PRODUCT  
NEWS

## Modification Notice

**Announcement of changes in internal component design to improve parts procurement of parts and conform to the latest DeviceNet specifications.**

•Networks Model DRT2-□D16SL(H)(-1)  
< Refer to the " [ Details of applicable model ] " . >

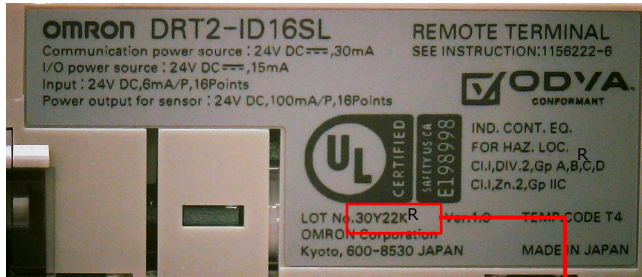
To improve parts procurement and conform to the latest DeviceNet specifications.

Before the change	After the change																				
<b>Correspondence CIP revision change</b> <table border="1"> <thead> <tr> <th>Model</th><th>CIP revision</th></tr> </thead> <tbody> <tr> <td>DRT2-ID16SL(-1)</td><td>Ver.1.1</td></tr> <tr> <td>DRT2-ID16SLH(-1)</td><td>Ver.1.1</td></tr> <tr> <td>DRT2-OD16SL(-1)</td><td>Ver.1.1</td></tr> <tr> <td>DRT2-OD16SLH(-1)</td><td>Ver.1.1</td></tr> </tbody> </table>	Model	CIP revision	DRT2-ID16SL(-1)	Ver.1.1	DRT2-ID16SLH(-1)	Ver.1.1	DRT2-OD16SL(-1)	Ver.1.1	DRT2-OD16SLH(-1)	Ver.1.1	<p>The CIP revision will be updated to comply with the latest DeviceNet specifications.</p> <table border="1"> <thead> <tr> <th>Model</th><th>CIP revision</th></tr> </thead> <tbody> <tr> <td>DRT2-ID16SL(-1)</td><td>Ver.1.2</td></tr> <tr> <td>DRT2-ID16SLH(-1)</td><td>Ver.1.2</td></tr> <tr> <td>DRT2-OD16SL(-1)</td><td>Ver.1.2</td></tr> <tr> <td>DRT2-OD16SLH(-1)</td><td>Ver.1.2</td></tr> </tbody> </table> <p>There is no impact on the operation and performance of this equipment due to the CIP revision. However, when connecting this equipment to a third-party master, the latest EDS file must be installed on your third-party configurator. Download the latest EDS file from our website.</p>	Model	CIP revision	DRT2-ID16SL(-1)	Ver.1.2	DRT2-ID16SLH(-1)	Ver.1.2	DRT2-OD16SL(-1)	Ver.1.2	DRT2-OD16SLH(-1)	Ver.1.2

Model	CIP revision																				
DRT2-ID16SL(-1)	Ver.1.1																				
DRT2-ID16SLH(-1)	Ver.1.1																				
DRT2-OD16SL(-1)	Ver.1.1																				
DRT2-OD16SLH(-1)	Ver.1.1																				
Model	CIP revision																				
DRT2-ID16SL(-1)	Ver.1.2																				
DRT2-ID16SLH(-1)	Ver.1.2																				
DRT2-OD16SL(-1)	Ver.1.2																				
DRT2-OD16SLH(-1)	Ver.1.2																				
<b>Change of internal parts</b>	<p>This designing change does not influence any specification, performance, and RoHS certification</p>
